RECEIVED BY THE
MILWAUKIE PLANNING
DEPARTMENT ON
AUGUST 18, 2017.

From: [Kurt Schultz](#)
To: [Kolias, Vera](#)
Subject: RE: DLC list of design recommendations to PC
Date: Friday, August 18, 2017 8:37:57 AM
Attachments: [Revisions 8-18-17 for planning commission.pdf](#)

DR-2017-001 (New mixed-use development at 2036 SE Washington St)

NORTH ELEVATION - WINDOW AREA CALCULATIONS:

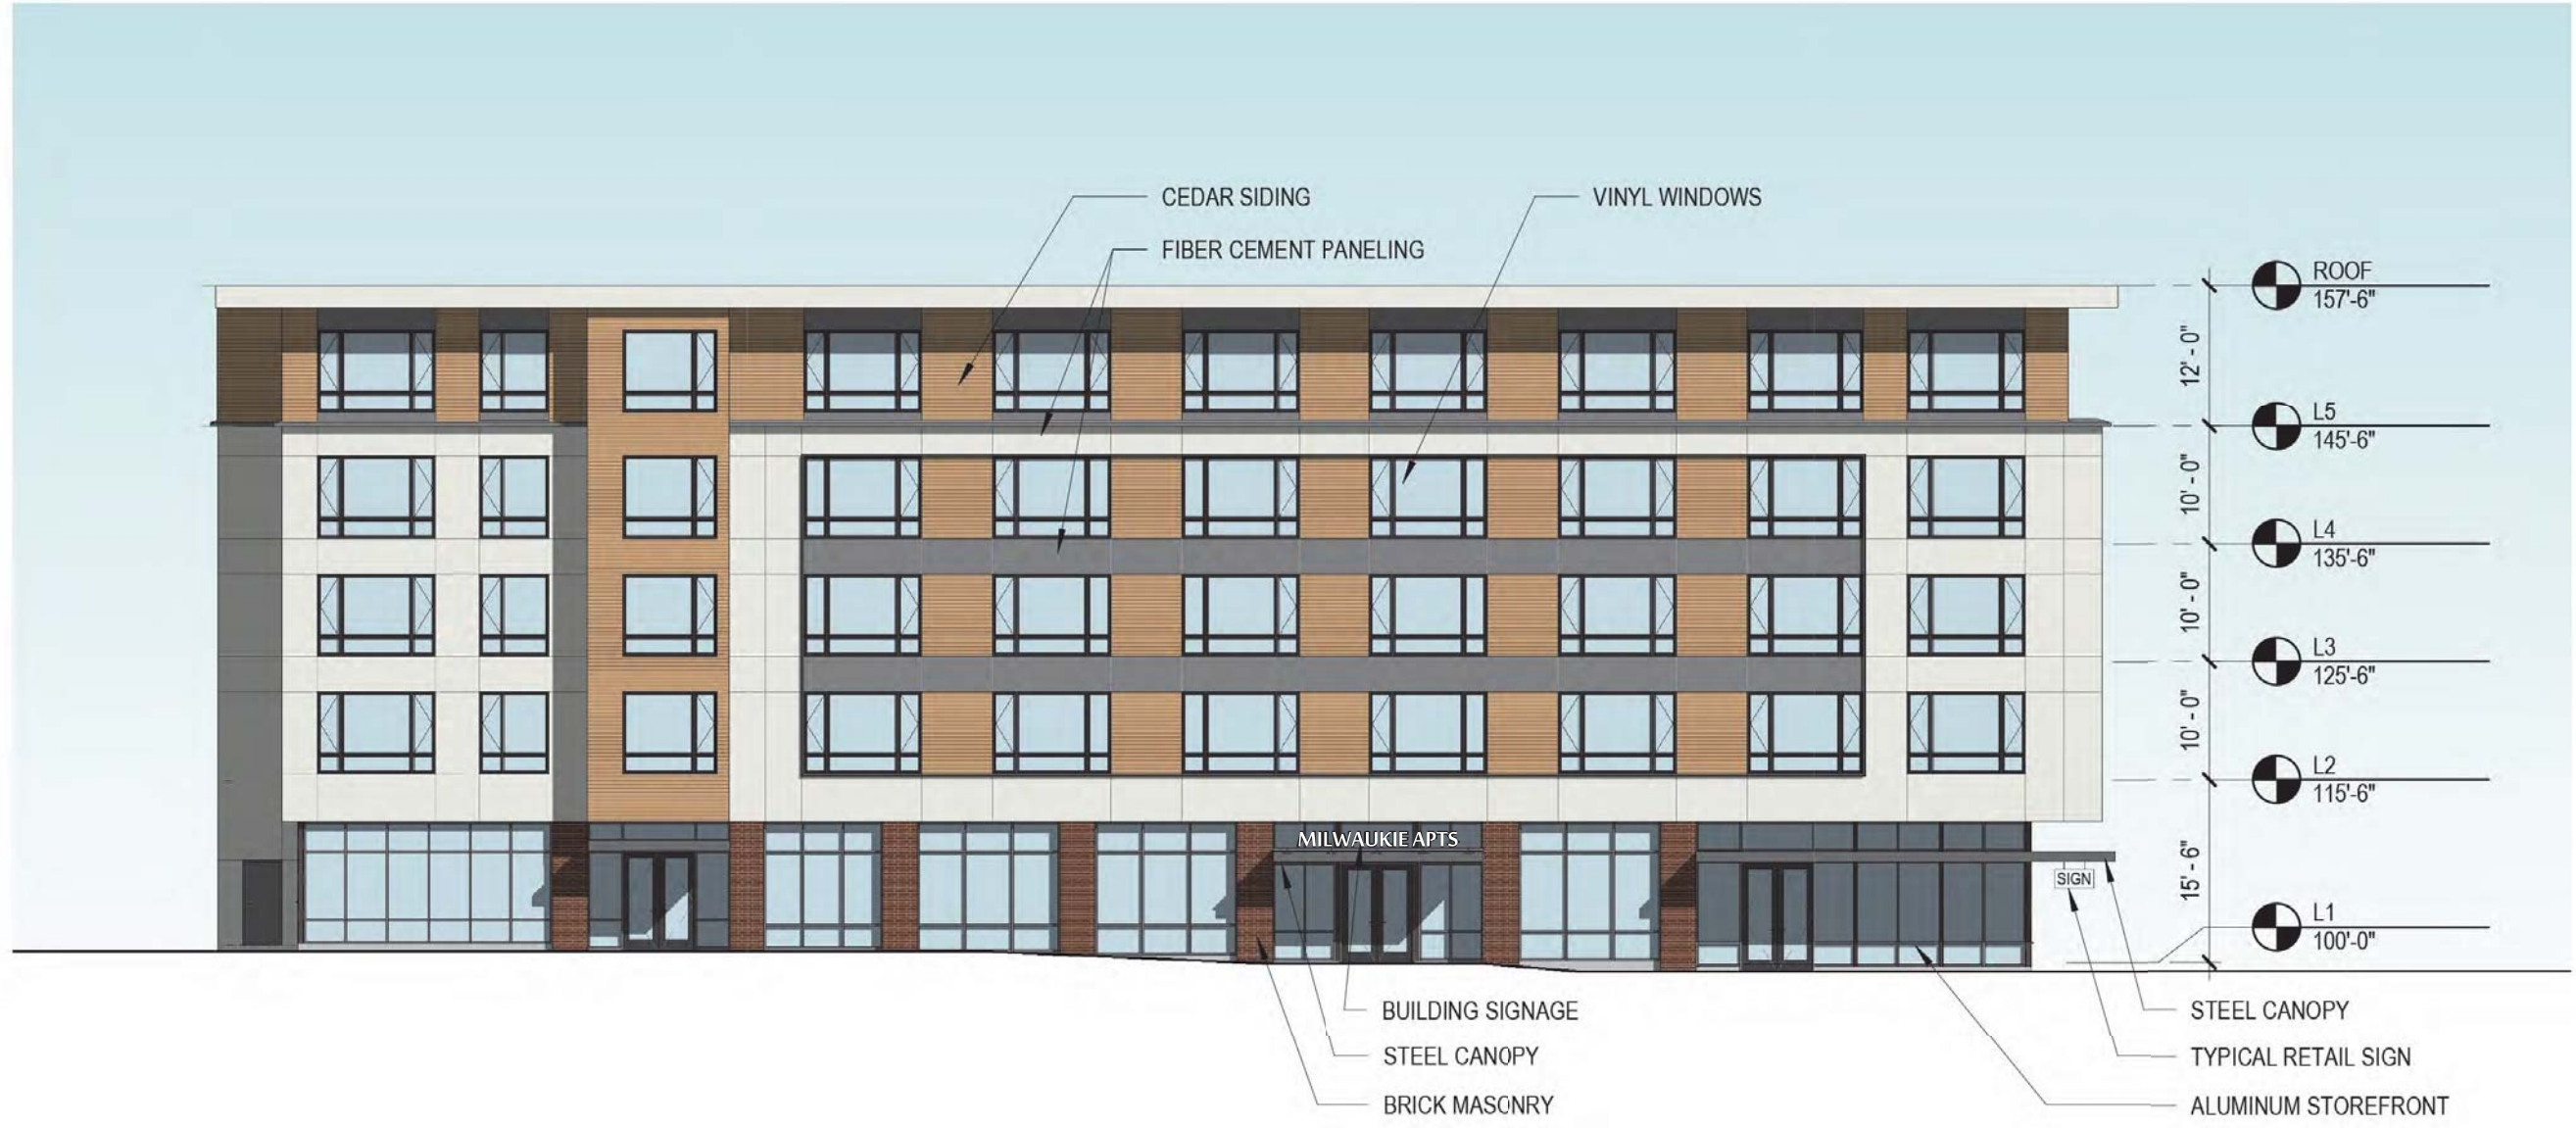
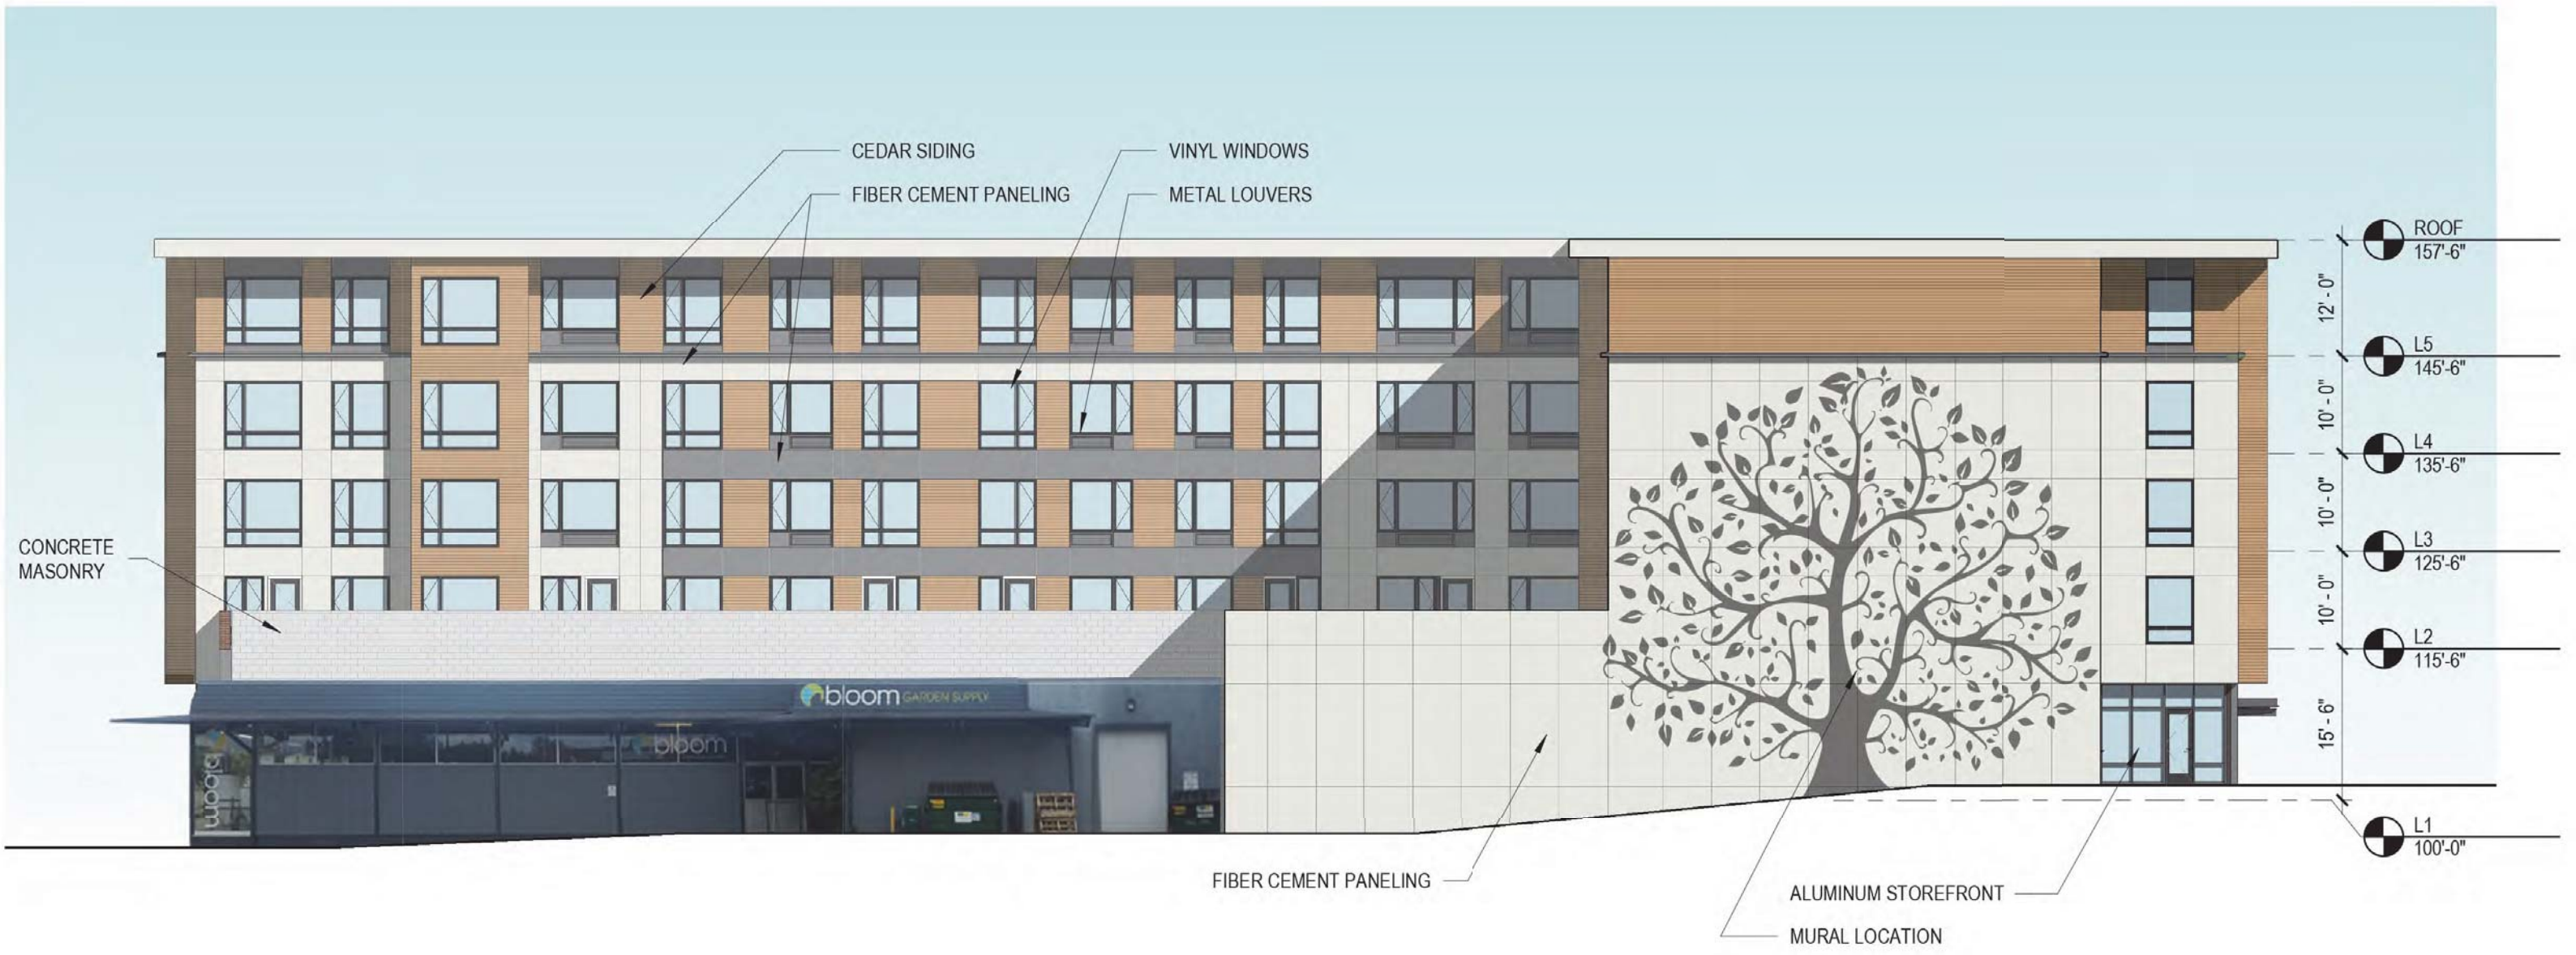
- Washington Street elevation

Increase the amount of transparency along the ground level, considering the garage door, the art area(s), and other options potentially using translucent features proportional to the retail storefront. **On the north elevation we now show graphically the art locations integrated into the building ground floor pattern. We also increased the amount of glazing in the north elevation so our ground floor glazing percentage is now 41%, over the 40% threshold**

LEVELS 2-5 WALL AREA - 9,439 SF (100%)
 WINDOW AREA - 3,325 SF (35%)

GROUND FLOOR WALL AREA - 3,064 SF (100%)
 STOREFRONT AREA - 1,262 SF (41%)

1 WALL SECTION - NO SETBACK
3/8" = 1'-0"

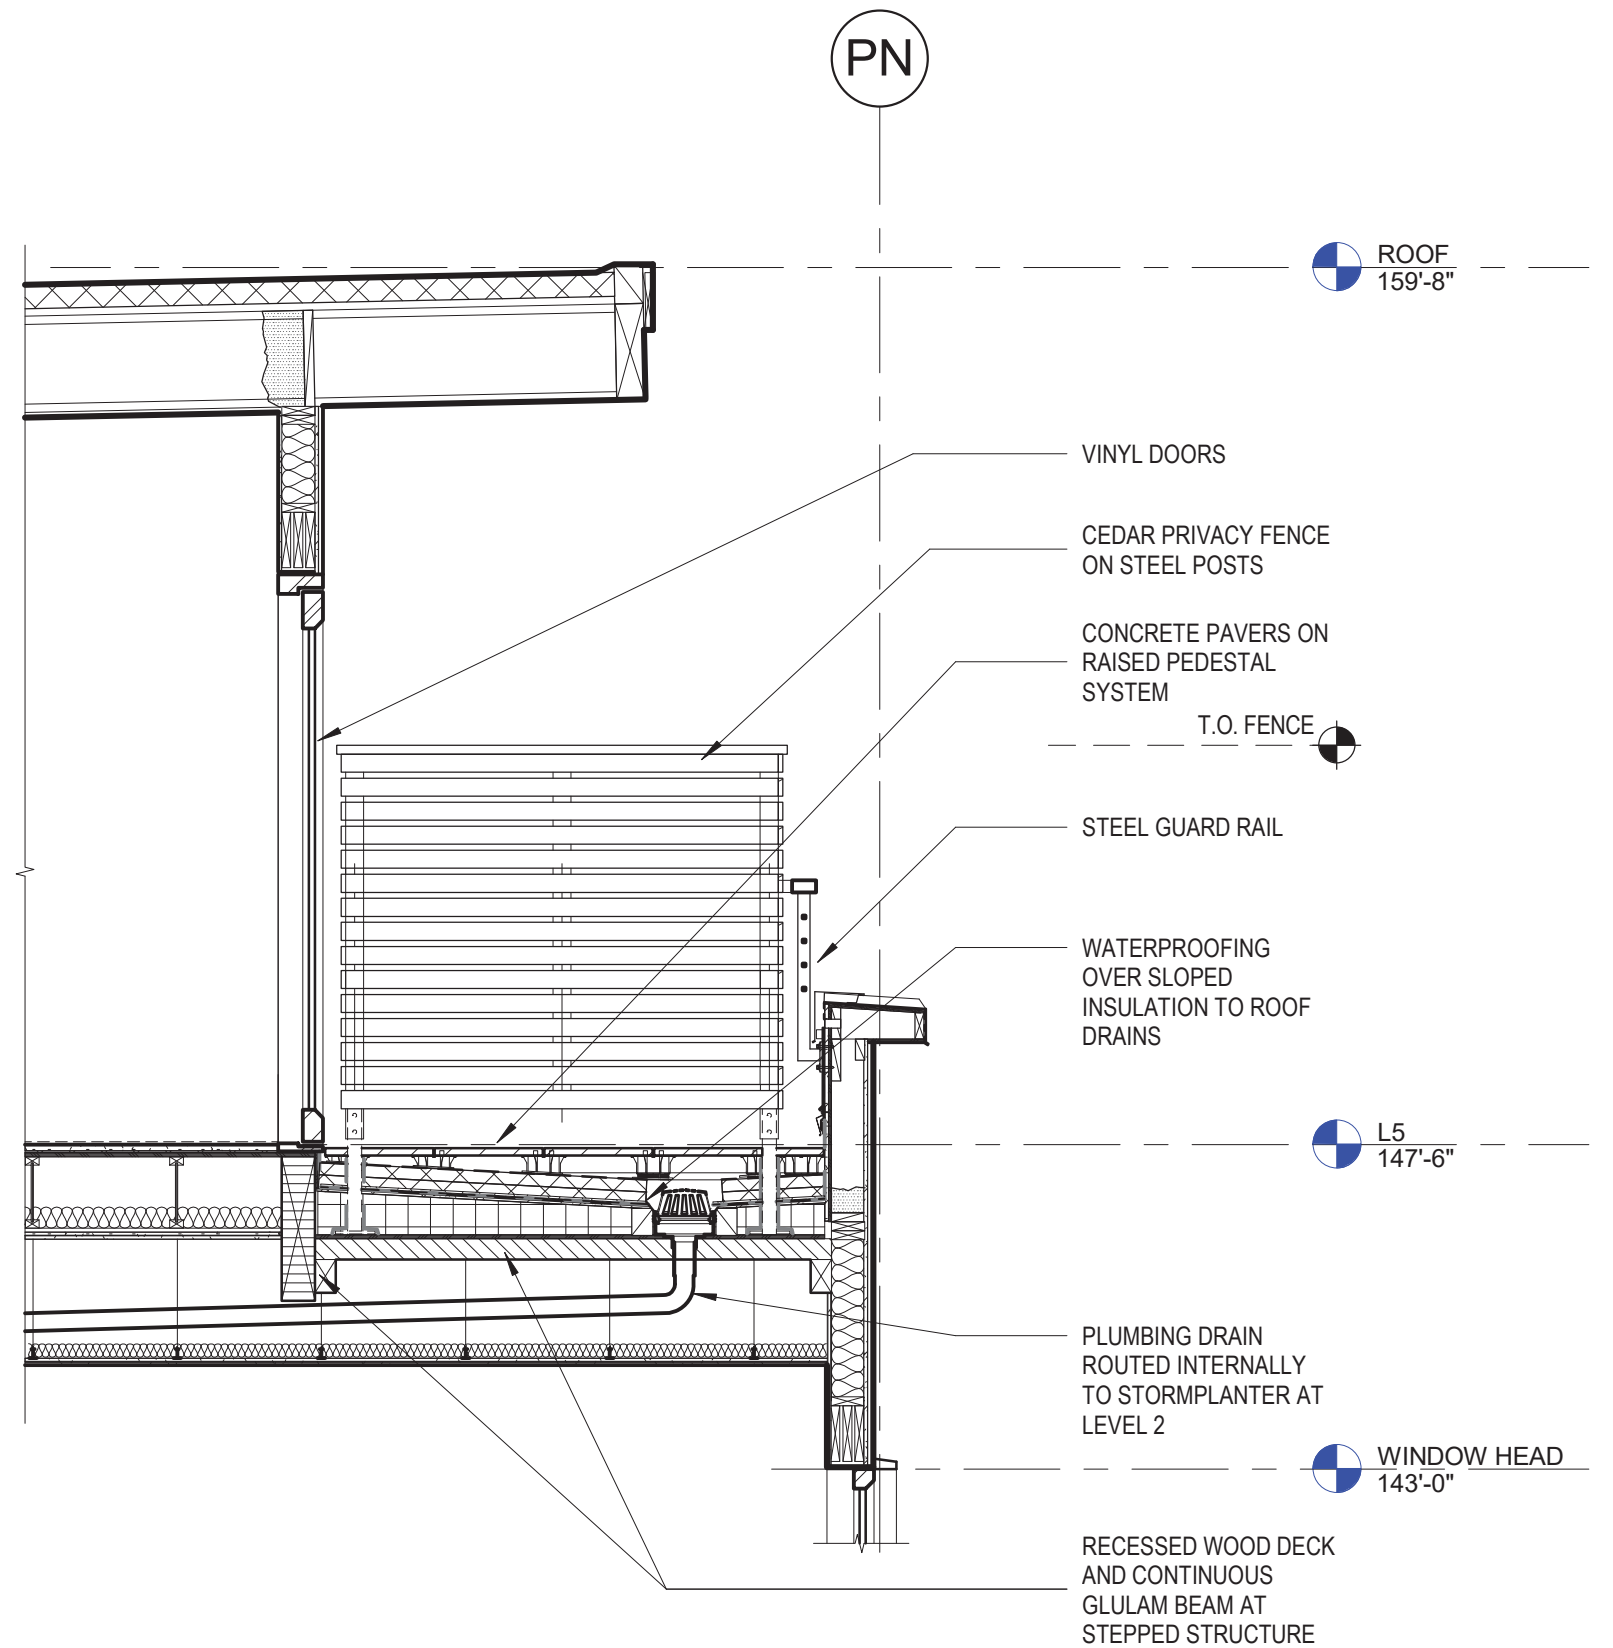
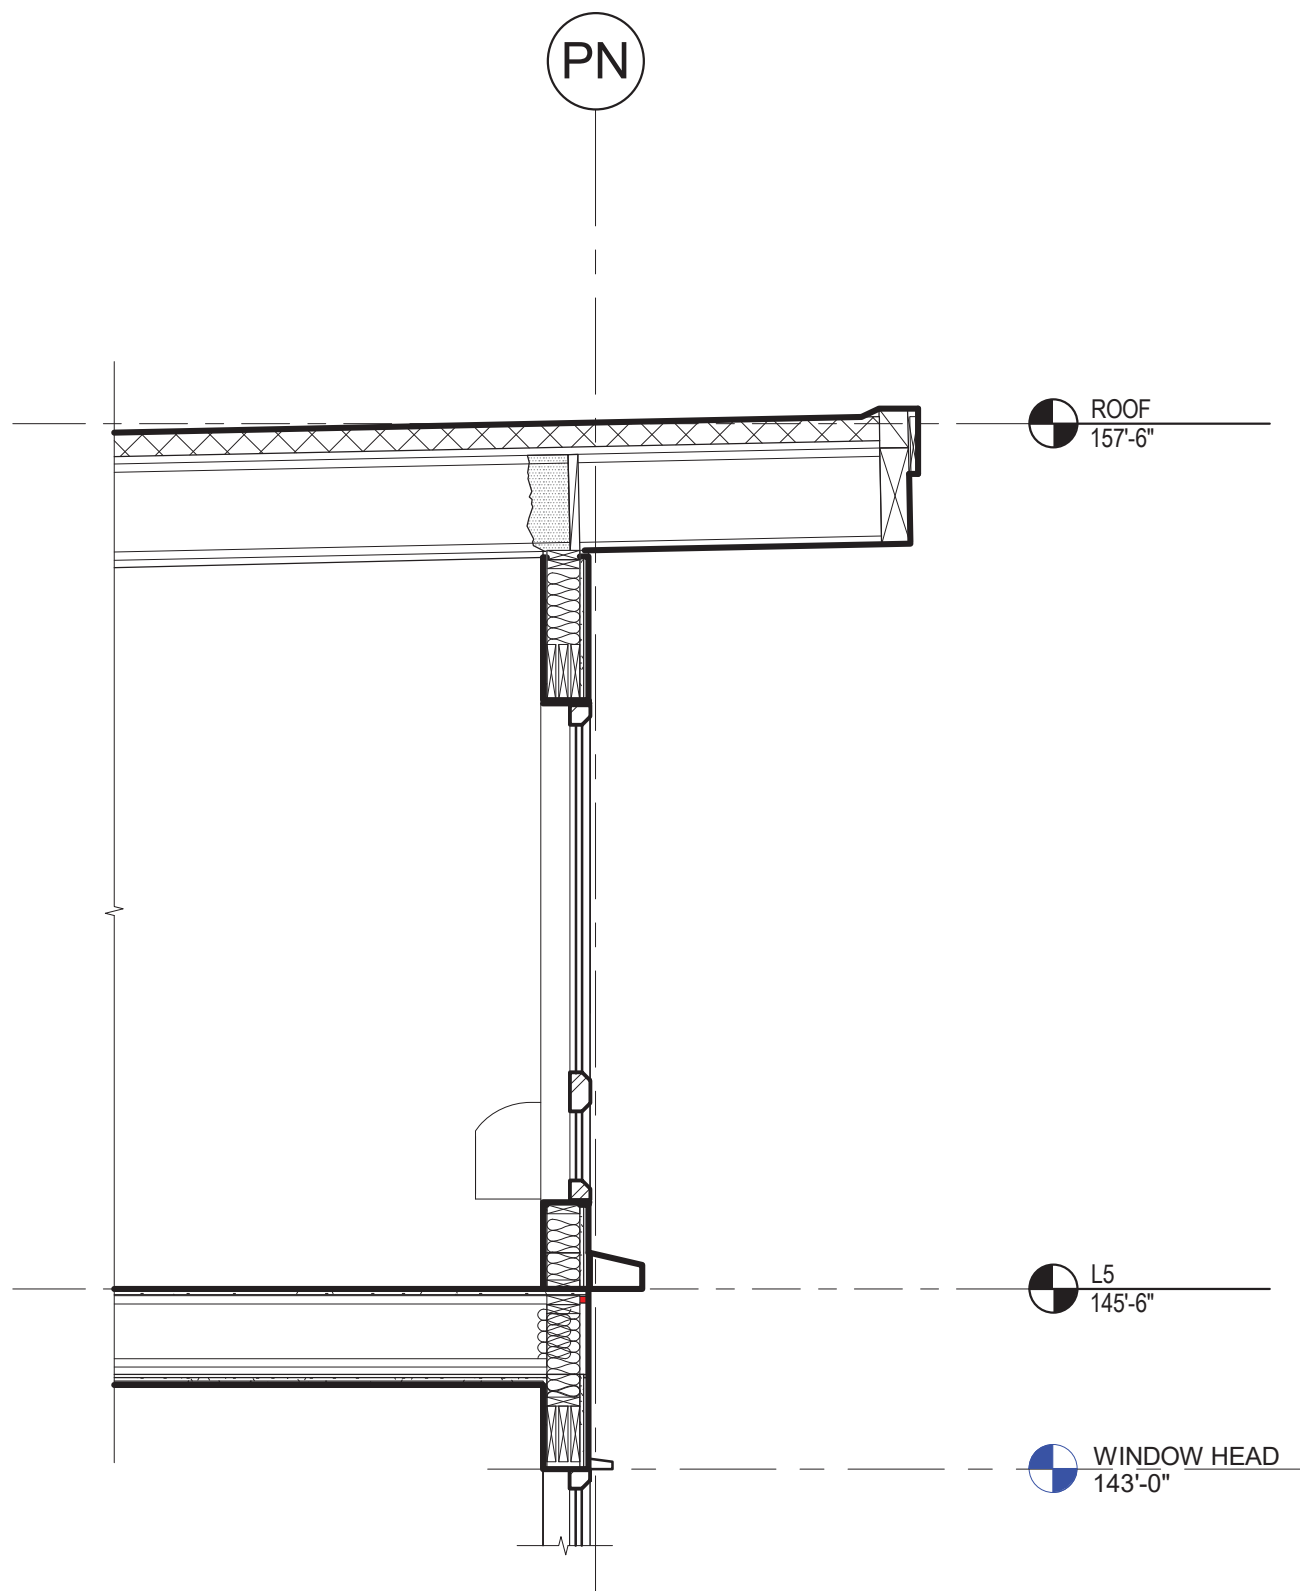
- The Planning Commission should review the 5th floor and require a minimum 4-ft step back or consider other alternatives or options to reduce massing, specifically on the Washington Street and 21st Avenue elevations. (Note: The Committee was fine with the variance request for the 4th floor and for the 5th floor on the Main Street elevation.) **We have added a building section that shows the complicated construction to build the setback. Due to the thickened building structure at the level 5 floor line, we would have to raise the building 2'-2" in height to maintain the same the ceiling height on level 4. This would increase our building height from 57'-6 tall to 59'-8". The construction cost for this revision would be an increase of \$530,000 per R&H Construction. Coupled with the loss of units and rentable area, this change impacts the project by over \$1,000,000 which is not feasible to the viability of the project.**

- *Detailed information regarding the feasibility of the step back should be provided, or any additional alternatives to the design to mitigate/respond to the purpose of the standard.*
